Fwd: The Ridings -- Proposed sloped granite curbing

**Planning Board
Grafton, MA**

Exhibit 13

**MassDOT detail for sloped granite curbing E 106.5.0.pdf**
20K

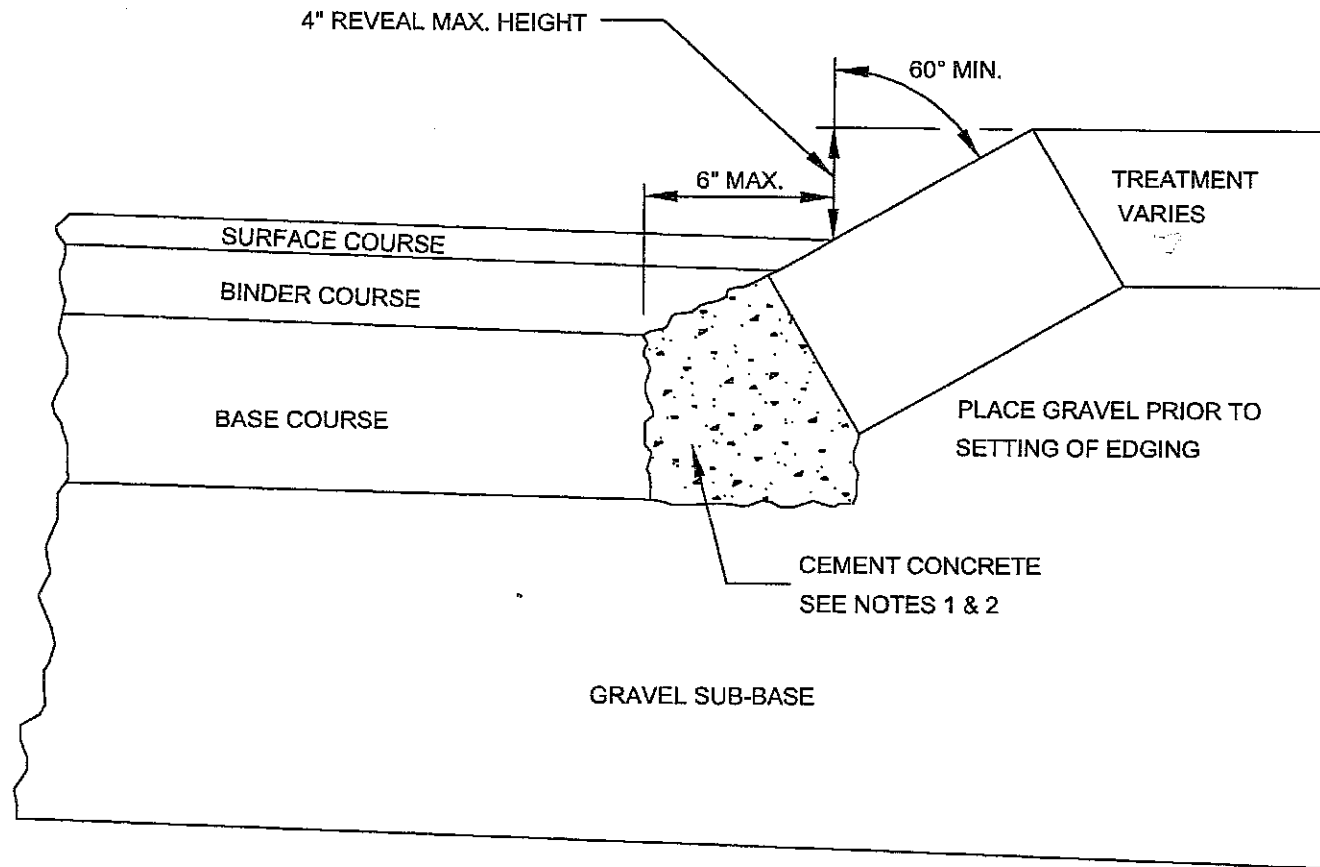
Pursuant to the discussion at the last Planning Board meeting, we hope to convince the Board that sloped granite curbing is an appropriate choice on this project.

Attached is a copy of a detail from the Massachusetts Department of Transportation (MassDOT) book of Construction Standard Details. It appears on page 23 of 141 at the link below. Our proposed detail, on sheet D2 of the Definitive Subdivision Plans, calls for the same 4" reveal as prescribed by MassDOT. I think the chairman had wondered aloud whether that was sufficient and our response is that this is the MassDOT standard and the same dimensions as the sloped granite curbs installed in multiple other Towns over decades now without any problems.
